PRODUCT CHANGE NOTICE

Shipping Tube Change for Intersil MSOP Packaged Products

**Refer to:
PCN11059**

Date: June 17, 2011

Current – Round Profile

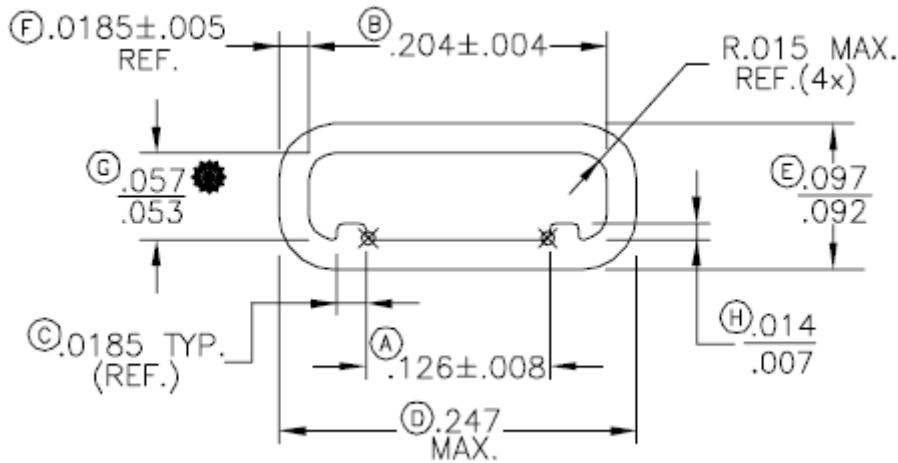
This notice is to inform you that Intersil is changing the anti-static tube used for packing/shipping of MSOP (Mini Small Outline Plastic) packaged products from the Carsem, STATS ChipPAC, and Unisem facilities located in Malaysia. The change from a round profile (current) tube to a rectangular / square profile (new) tube will eliminate lead contact with the tube body thereby reducing the potential for bent leads.

The industry standard tubes are made of an anti-static material. There will be no change in tube length or the quantity of units packed in a tube. Dimensional information and drawings of each type are included on the next page for reference.
